CLARIFICATIONS

Title: Development and Supply of the VVPSS Rupture Disc Assembly

Pre-bid Clarifications to the bidders (GEM/2023/B/3744658)

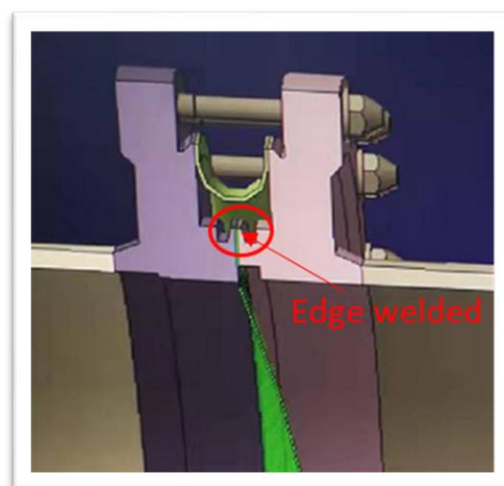
3. **Clarification:** In the current design, it seems that the RD “holder” is the assembly of the two flanges. It is difficult to be assembled and disassembled. Could you please provide us more details about this point?

Answer: The holder is a specific piece of equipment that is designed to clamp the rupture disc into the assembly. IO anticipates that in order to achieve the leak-tightness requirements, the edges of the holder and disc will require to be welded. See below:

This edge, which is to be welded, shall be sufficiently large to enable 3 times

welding a new rupture disc before the holder needs to be replaced.

If the contractor can achieve the leak tightness requirements without welding, then this would be acceptable to IO and an advantage.

A secondary enclosure is then formed by an outer seal, creating a small enclosure that can be monitored for leaks.
